**ELECTRICAL DISTRIBUTION SYSTEM AT TALCHER
TALCHER FERTILIZERS LIMITED
NIT NO. : PNPM/PC183/E/4006 DATED 27.03.2021
Amendment – IV dated 07.06.2021**

SL. NO.	REFERENCE OF BIDDING DOCUMENT				AMENDMENT TYPE M/D/A	MODIFICATION
	Part/Sec.	Page No.	Clause No.	NIT Description		
1.	Section-VI-3.1 Design Philosophy- Electrical	30 of 97	5.21	HVAC System	M	<p>The substation Switchgear Room, UPS & Battery Charger room, ECMS room, Control Room, Maintenance Room, Engineer Room, and Shift Office shall be fully air conditioned through centralised HVAC with (n+1) system with proper ducting arrangement for uniform cooling , however all the equipment shall be suitable for operation under specified ambient condition even on failure of air conditioning system. The substation shall have HVAC system so that the temperature inside the substation is maintained at 25 Deg.C in all conditions. Provision for remote alarm on failure of air conditioning system shall be provided. Indication of substation and control room temperature shall be provided. Heat load to be calculated on the basis of heat generation in the substation during peak summer period. Fire damper to be provided in the ventilation duct of th

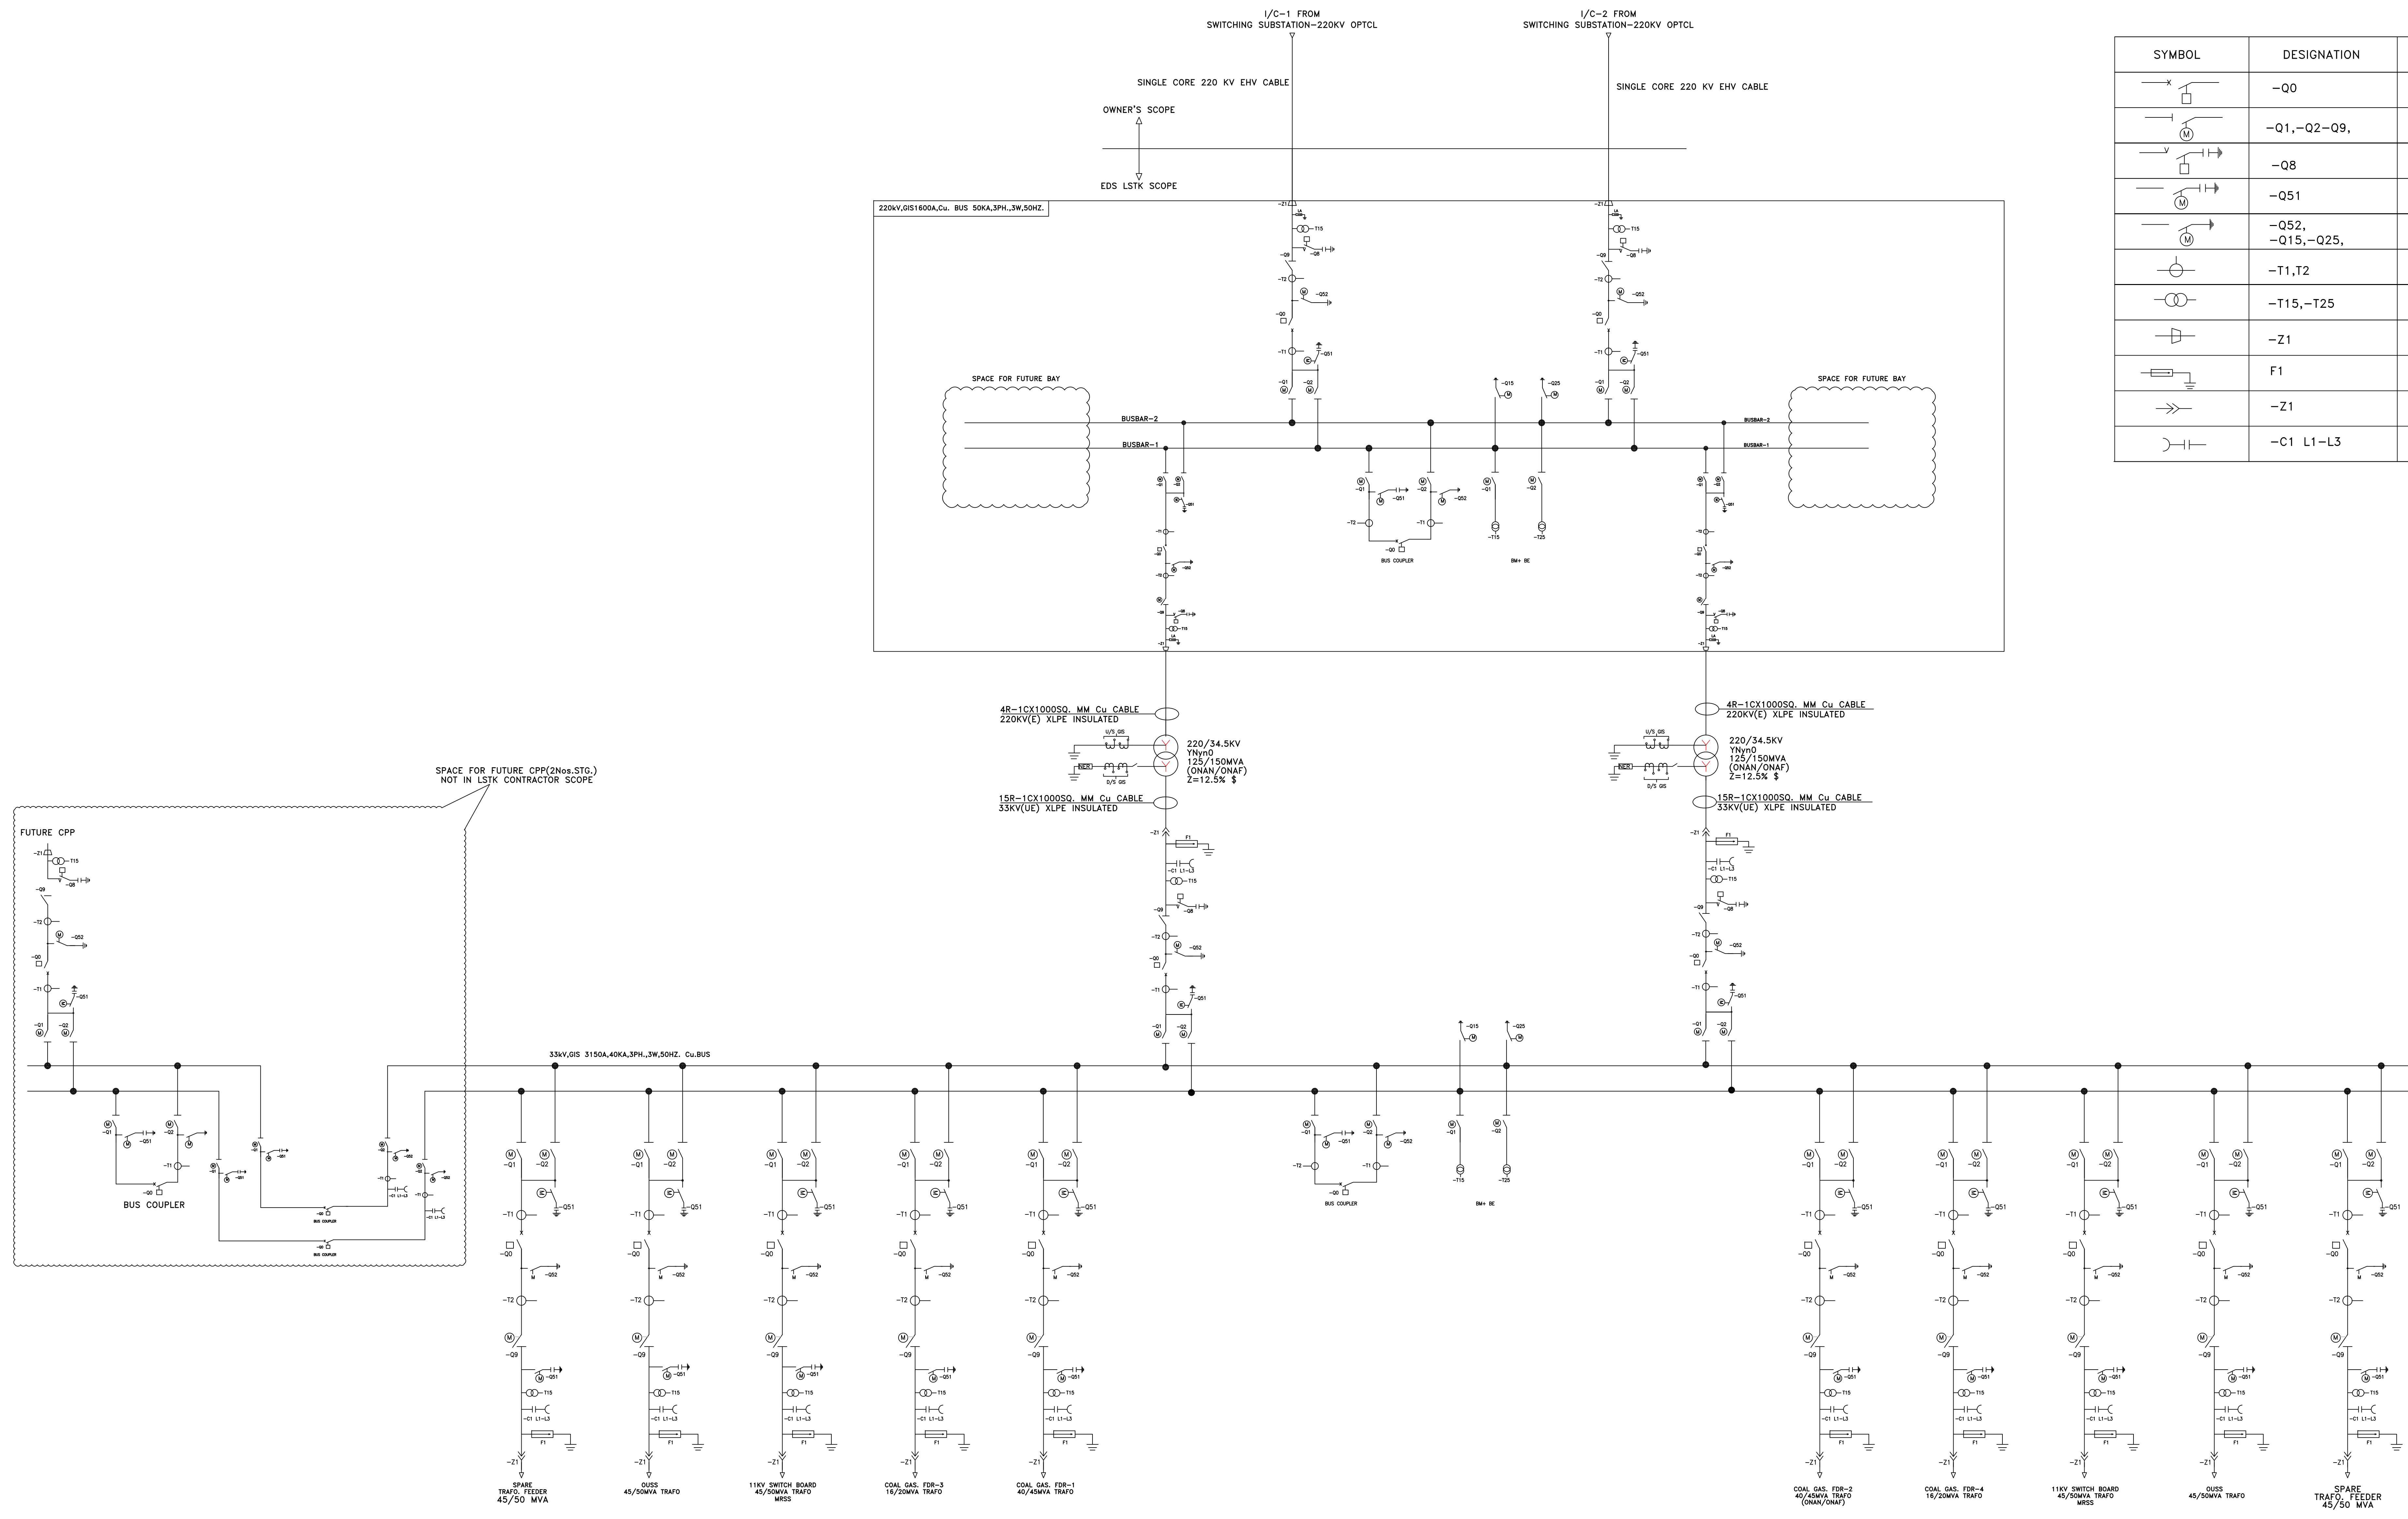
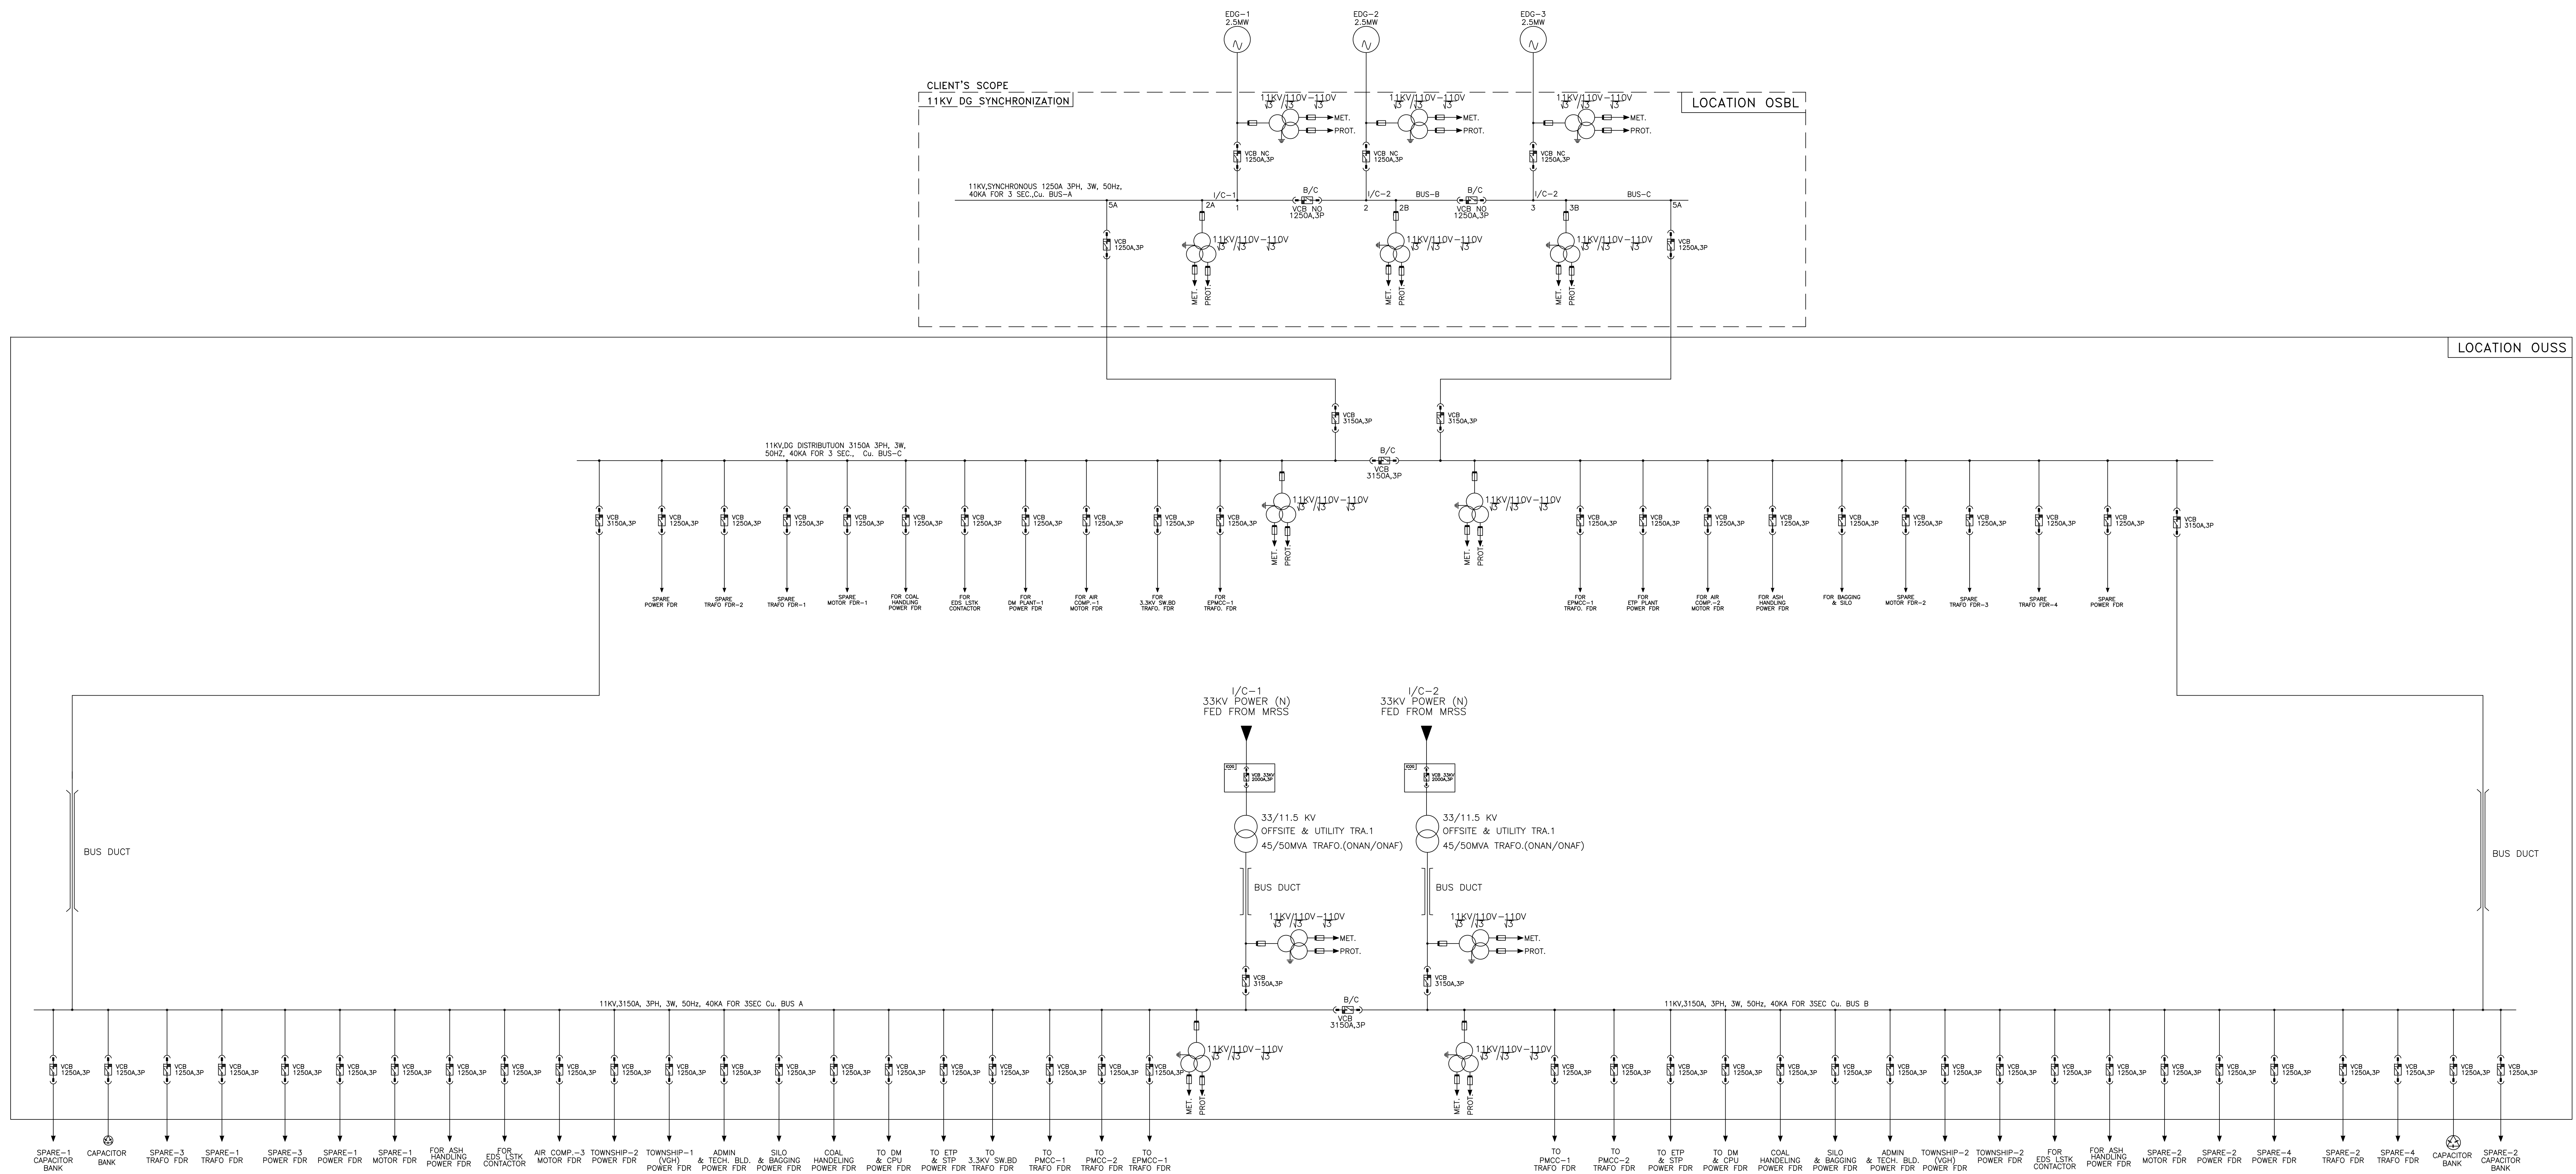
16.	PC183-7411- 0985A			220kV & 33 kV GIS Single Line Diagram	M	Revised Single Line Diagram is attached
17.	PC183-7411- 0985B			11 KV Single Line Diagram (OUSS)	M	Revised Single Line Diagram is attached

DRG. No.: PC183-0000-0011
 FILE NO.: PC183-000-0011_RP3_OP

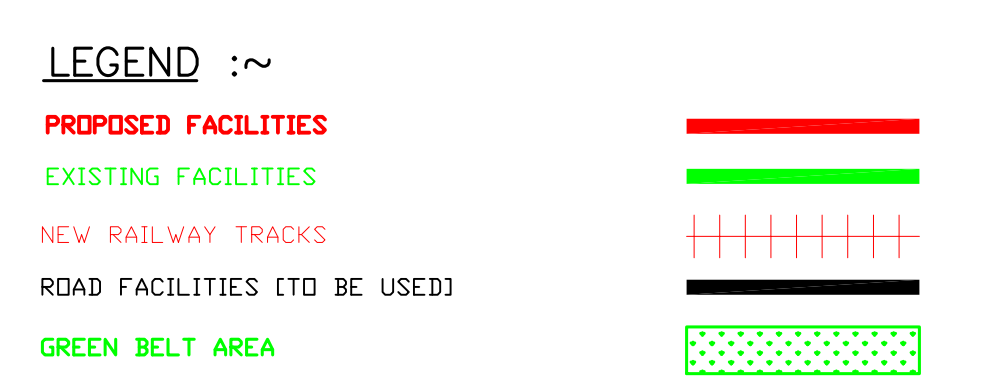
23.	Section : VI – 3.2.1, Fire Fighting System	6 of 8	8.2		A	CO2 gas flooding system shall also be provided in cable cellar.
24.	Section : VI – 3.2.1, Fire Fighting System				A	Conceptual Fire Water Facility for OSBL (Drg. No. PC183–0000–0011)
